DATE ~~R~~ Dec. 6/02**V2500-A1 PROPULSION SYSTEMS SERVICE BULLETIN**

This document transmits Revision 5 to Service Bulletin EV2500-72-0120

V2500-ENG-72-0120

ENGINE - NO.4 BEARING COMPARTMENT - PROVIDE A NEW NO.4 BEARING SCAVENGE TUBE ASSEMBLY
AND GASKET

Location of the No.4 Bearing Scavenge Tube Assembly For Engines Which Incorporate
Reference (2), But Do Not Incorporate Reference (3)
Fig.1 (Sheet 1 of 2)

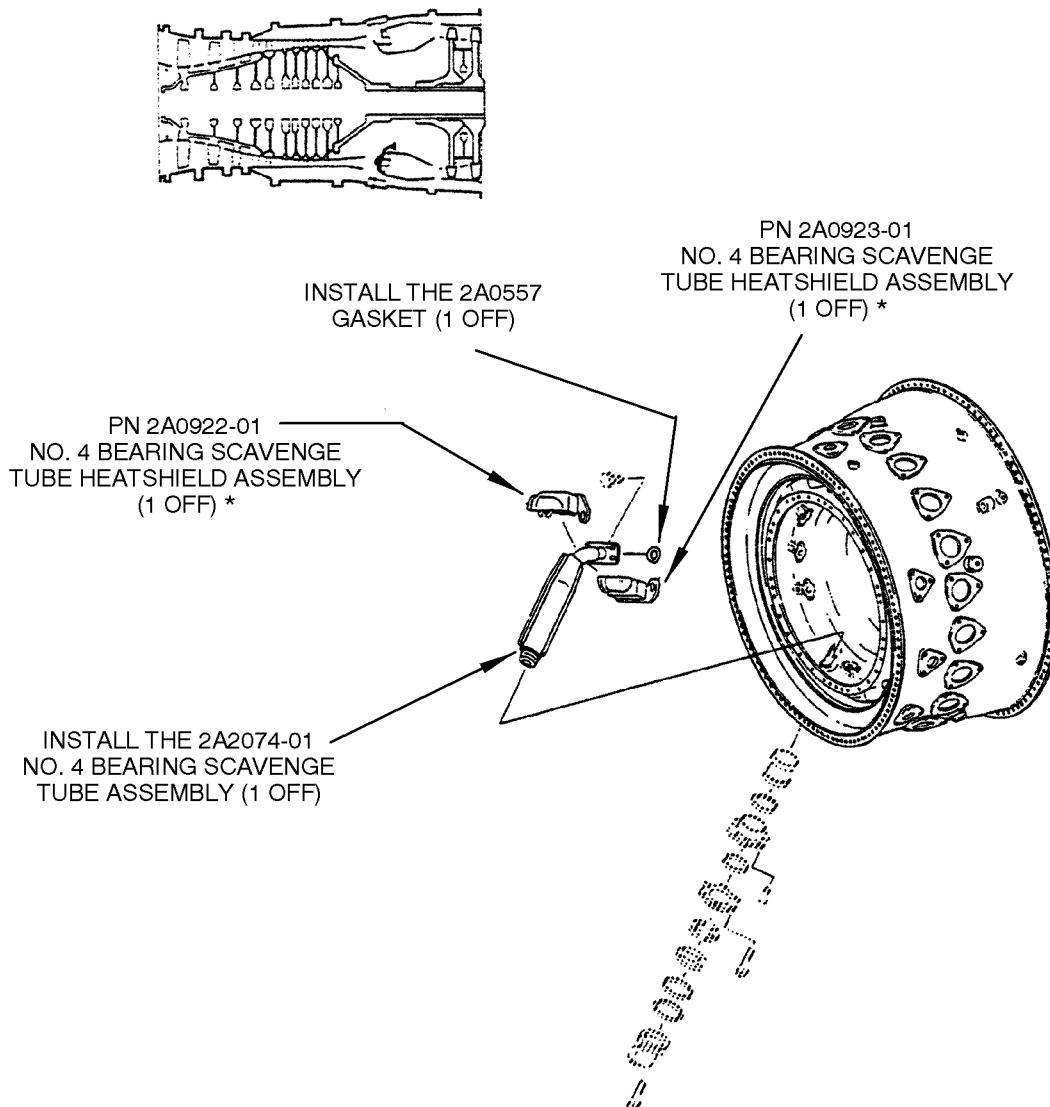
- (1) Install the 2A0557 Gasket and the 2A2074-01 No.4 Bearing Scavenge Tube Assembly (1 off). Use the approved procedure in Reference (1), Chapter/Section 72-42-00, Assembly. See Figure 1.
- (2) Do not install the No.4 Bearing Tube Heatshields 2A0922-01 and 2A0923-01 when you do this Service Bulletin, for engines which do not incorporate Reference (2), and for engines which incorporate Reference (3). See Figure 1.

* THESE PARTS ARE REMOVED AND WILL
NOT BE INSTALLED AGAIN WITH THE NEW
CONFIGURATION

Location of the No.4 Bearing Scavenge Tube Assembly For Engines Which Do Not
Incorporate Reference (2), and for Engines Which Incorporate Reference (3)
Fig.1 (Sheet 2 of 2)

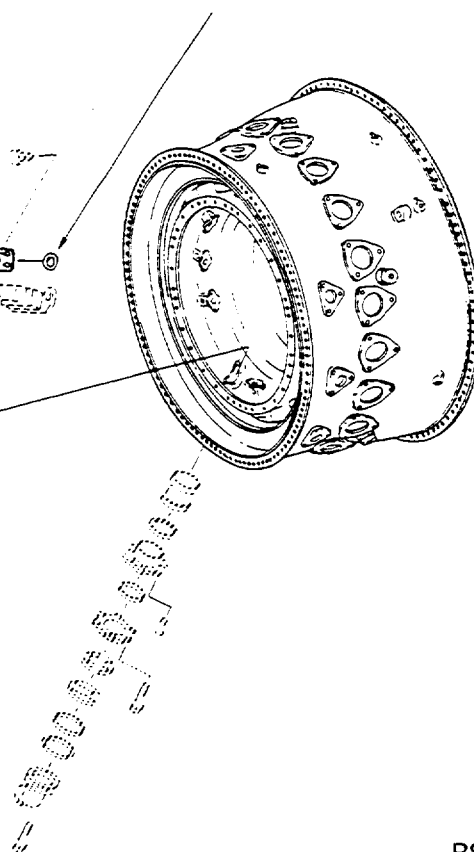
INSTALL THE 2A0557
GASKET (1 off)

INSTALL THE
2A2074 - 01 No.4 BEARING
SCAVENGE TUBE ASSEMBLY
(1 off)

Family Tree - No.4 Bearing Scavenge Tube Assembly Ref. Catalog Sequence No.
72-42-20, Fig. 02, Item 020
Figure 2

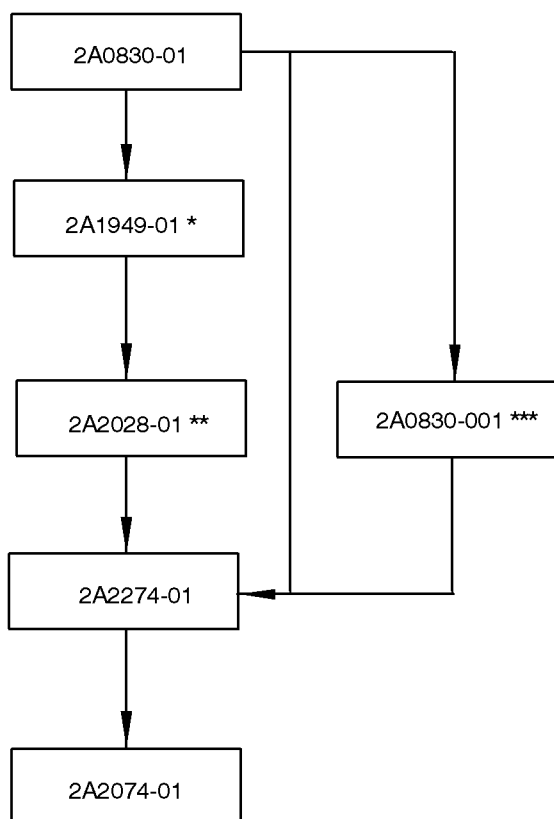
*** V2500-ENG-70-0004 (PART 1)
REMOVE THE HEATSHIELD FROM
THE 2A0830-01 NO. 4 BEARING
SCAVENGE TUBE ASSEMBLY

*** V2500-ENG-70-0004 (PART 2)
REMOVE THE HEATSHIELD FROM
THE 2A0830-01 NO. 4 BEARING
SCAVENGE TUBE ASSEMBLY

V2500-ENG-72-0120 PROVIDE NEW
FRONT AND REAR NUMBER 4
BEARING DUCTS WITH OIL
DRAIN HOLES
